SANITARY SURVEY FORM - INVENTORY

PWSID 0400030 Date of Survey: 03/24/2016		SYSTEM NAME <u>Pisinemo Intertie</u>	
DATE OF SURVEY 03/24/2016		RESERVATION Tohono O'odham	
(SYSTEM REPRESENTATIVE) Vernetto Ramon--Lab Supervisor		(OTHER REPRESENTATIVE) Amber Ramon--Commercial Rep/Lab	
SYSTEM ADDRESS Addressee <u>Tohono O'odham Utility Authority (TOUA)--C/O Myrt McIntyre, Manager</u> Street <u>P.O. Box 816</u> City <u>Sells</u> State <u>AZ</u> Zip <u>85634</u> System Phone <u>(520)383-5830</u> Fax <u>(520)383-2218</u>		SYSTEM OWNER Addressee <u>Tohono O'odham Utility Authority (TOUA)</u> Street <u>P.O. Box 816</u> City <u>Sells</u> State <u>Az</u> Zip <u>85634</u> Owner Phone <u>(520) 383-5830</u> Fax <u>(520) 383-2218</u>	
LOCATION OF SYSTEM Nearest City <u>Sells, AZ</u> Description or Physical Address <u>Located approximately 36 miles NW of Sells, AZ, on HWY 86 and then 10 miles south on BIA Route 21.</u>			
OPERATOR OF SYSTEM Name <u>Myrtle I. McIntyre, Manager</u> Certified Operator? <input checked="" type="checkbox"/> Yes <input type="checkbox"/> No <input type="checkbox"/> Not required Treatment Certification Level <u>Grade 3</u> Treatment Certification date <u>Expires 03/31/2019</

Pisinemo Intertie Schematic

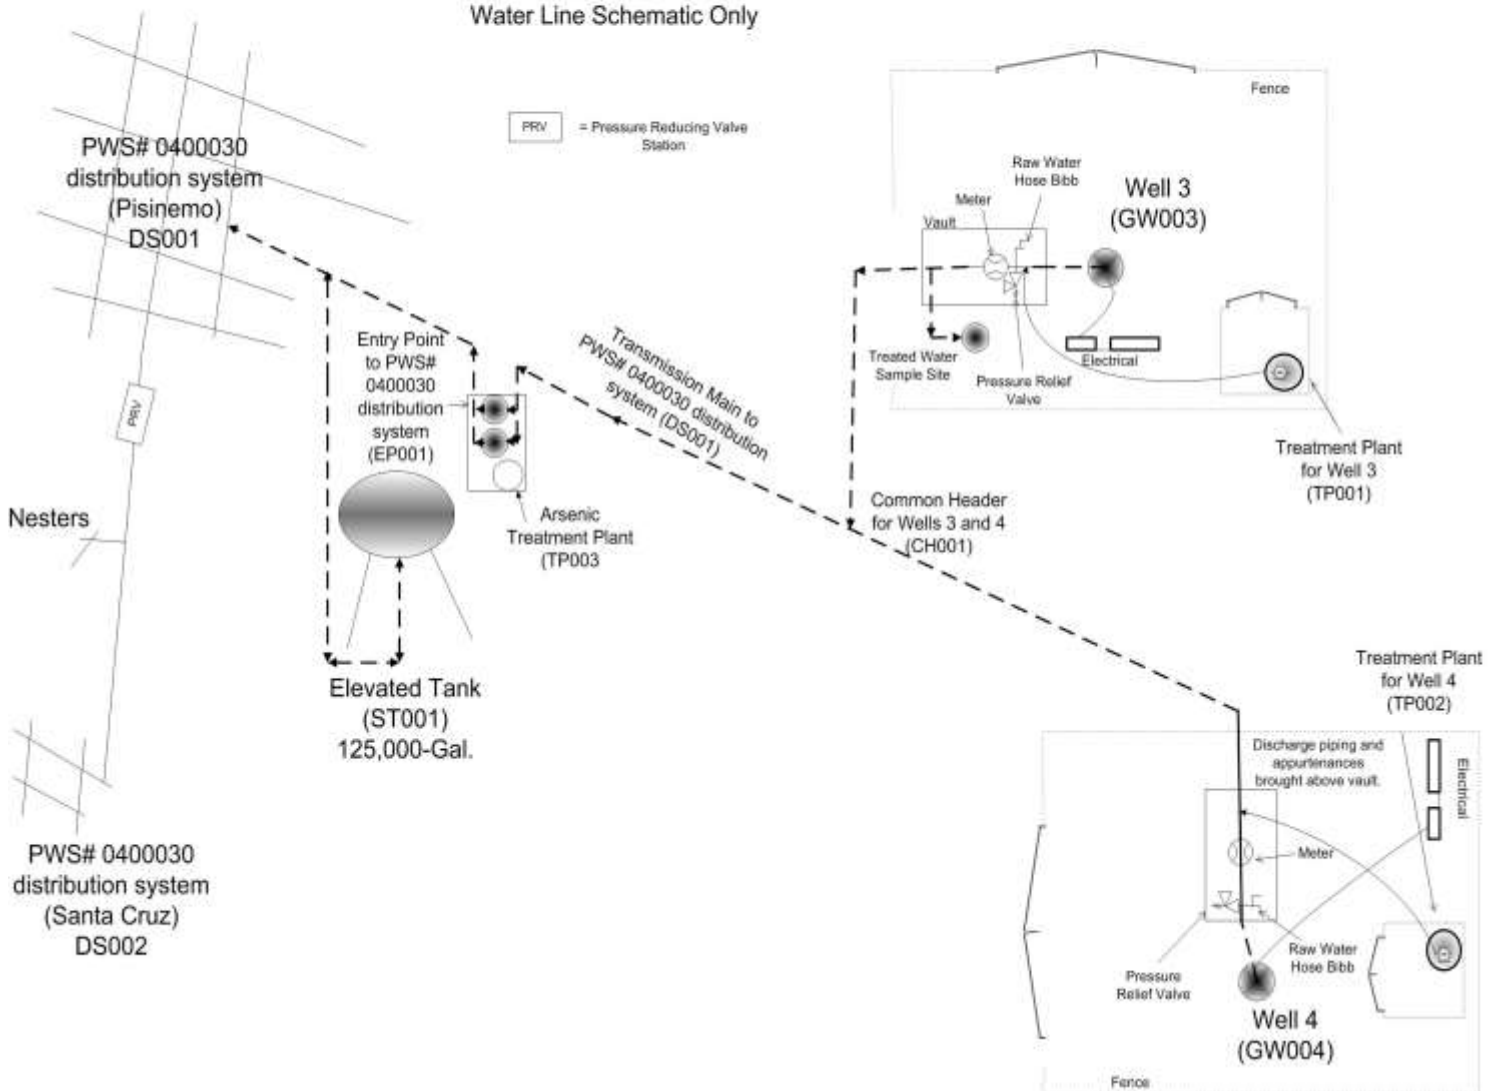
Comments: The system has air relief valves in the transmission lines. These valves are installed in small vaults below grade. The air relief piping does not extend above ground, which would make a potential cross-connection if the vault flooded; however, TOUA does not wish to extend the piping above ground. During previous surveys, it was explained that these vaults were often found and vandalized by illegal border crossers looking for water (the border crossers would break the valves off, which breaks the transmission line and would be a hazard for the water system due to depressurization of the transmission and distribution mains).

It was also noted during this sanitary survey that vehicles are running over the valve vaults near the roadways going to the wells. At one vault, it appeared an ATV had purposely run over a marked valve vault and broken the vault casing and lid. Protective bollards and more robust valve vaults (e.g., cast iron with locking lids) should be considered to provide protection. Additionally, TOUA should work towards proper backflow protection of automatic air relief valves in all of their systems where these valves are used. Val-Matic Floodsafe valves are now available for systems where the relief piping is kept below grade. The use of more robust valve vaults with locking lids would also be of benefit.

There is one pressure reducing valve on the line between Pisenemo and Santa Cruz/Nesters. The valves need adjustment or repair, as the pressure reading at a home in Santa Cruz was over 100 psi.
